Amendment No. 1
to
AS/NZS 2576:2005
Welding consumables for build-up and wear resistance

CORRECTION

Section 1 Figure 1.1

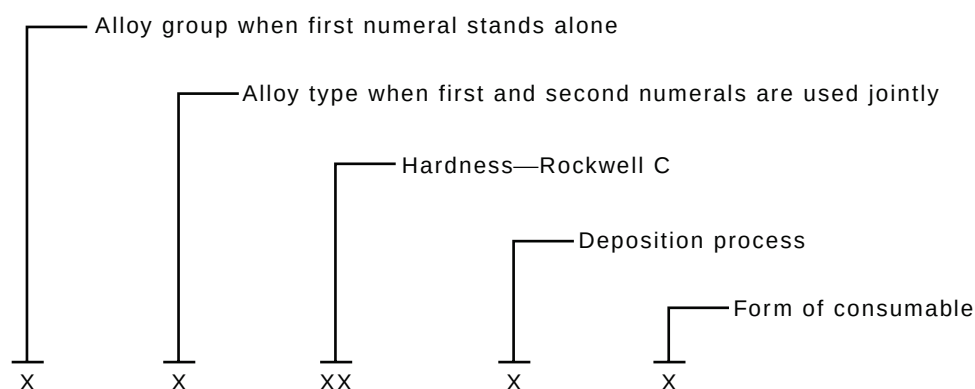
Delete existing Figure and replace with the following:

Example: 2360-A1—an austenitic chromium carbide iron, with a mean hardness within the range of 60 HRC to 64 HRC used for manual arc welding, supplied in a tubular form, with the deposited weld metal receiving no alloy contribution from the flux coating
